# UNITED STATES PATENT AND TRADEMARK OFFICE

10/519,144

Yutaka Iguchi

## **DETAILED ACTION**

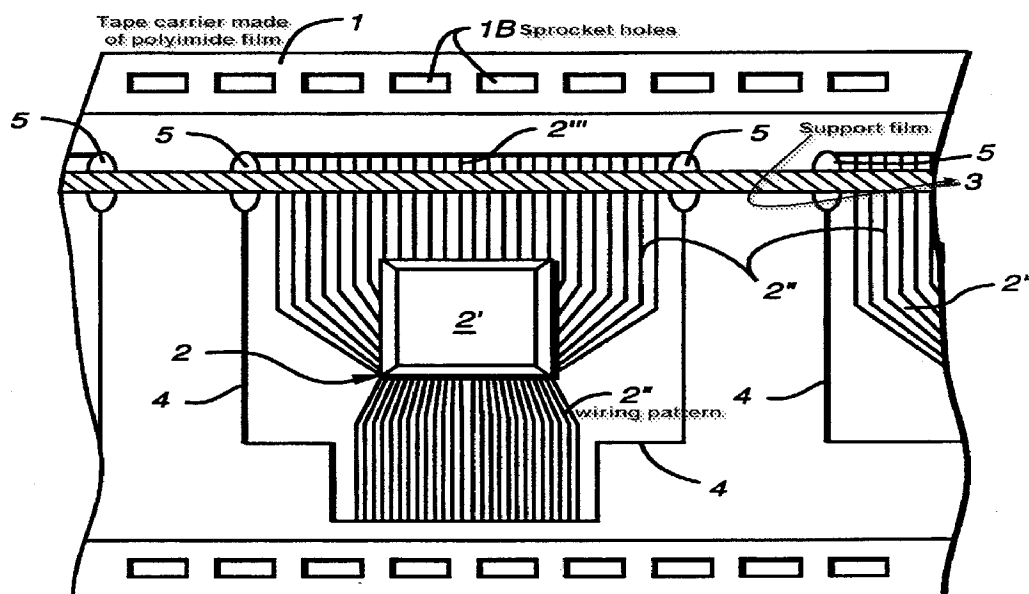
**Regarding claim 1**, a chip on film film carrier tape (figure 1 element 1) including a continuous insulating film (Tape carrier 1 may be made of polyimide film), a wiring pattern (figure 1 element 2", i.e. photolithography is performed employing a photoresist

to pattern and selectively etch the film to form lead patterns 2") formed of a conductor layer (see figures 1 and 2) provided on a surface of the insulating film (Tape carrier 1), and a row of sprocket holes (figure 1 element 1B) for use in conveyance of a film carrier tape provided on either lateral side of the wiring pattern on which electronic devices are to be mounted (Column 1 lines 25-29), characterized in that a center section of the insulating layer (See figures 1 and 2) other than opposite longitudinal edges where the sprocket holes (figure 1 element 1B) are formed is provided with a support film (figure 1 element 3) formed on another surface of the insulating film is provided ( figure 1 element 1), which surface is opposite to the surface on which the wiring pattern (see figure 1, the wiring pattern element 2" and the support film element 3) ; wherein the support film (figure 1 element 3) is not formed on the longitudinal edges of the insulating layer where the sprocket holes are formed; and wherein the support film and the sprocket holes are not coplanar. (As it depicted figure below, support film (element 3) and the sprocket holes (element 1B) are not lying in the same plane).
